The Sir Robert Ogden Evans Property Partnership Ltd
Proposed Residential Development, Dunningley Lane, Tingley

Stage One Road Safety Audit Designer's Response

4 December 2017
Version 1.0
Issue

Drawn by	Checked by	Date	Scale	Format
PJ	PI	2017	1:500/250	A1
Job Number	Drawing Number	Revision		
3103	3103 SK007 01	A

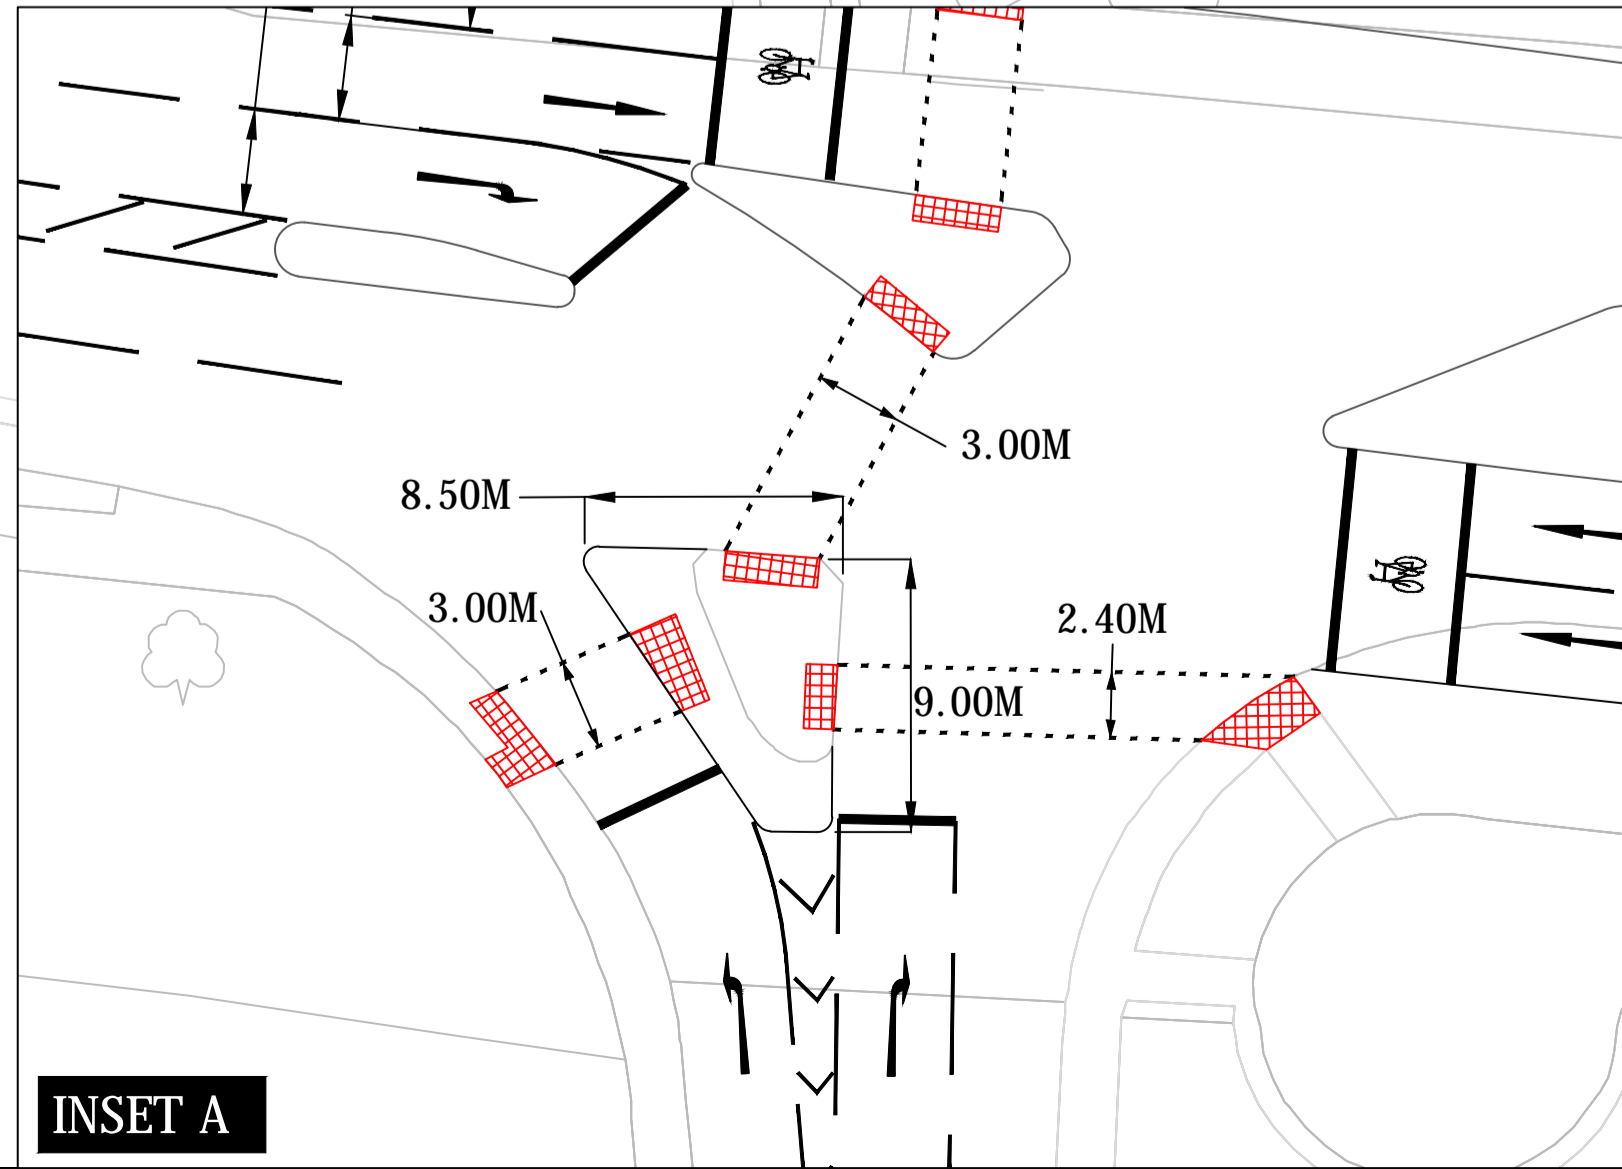
Location:	Smithy Lane / A650 junction
Summary:	Small pedestrian refuge
Description:	<p>The triangular pedestrian refuge at the junction of Smithy Lane with the A650 Bradford Road is very small considering it is proposed to have three pedestrian crossing points connected to it. Large groups of pedestrians, especially groups of school children, could form on this refuge and some may spill over onto the carriageway with the possibility of being struck by moving vehicles and consequent injury. Also, it was noted that the east- west crossing point on drawing 3103SK007 01 shows the crossing as having red tactiles (i.e. a formal crossing) but the associated text reads “pedestrian crossing facilities to be retained” - the existing facilities on this leg are uncontrolled.</p>
Recommendation:	<p>It is recommended that if it the island is to be retained as part of the crossing facility, it should be enlarged to accommodate the peak number of pedestrians likely to use it. If not currently proposed, the eastern-most leg should be signal controlled as part of the scheme.</p>

Designer Response:	<p>Recommendation accepted.</p> <p>The size of the island has been maximised in accordance with the swept path analysis undertaken. The revised arrangement is demonstrated on Fore Consulting drawing 3103/SK007/001A.</p> <p>It is proposed that the existing uncontrolled crossing is retained. The note on the drawing has been amended accordingly, and the precise details in terms of tactile paving and kerbs will be addressed as part of the detailed design process.</p>
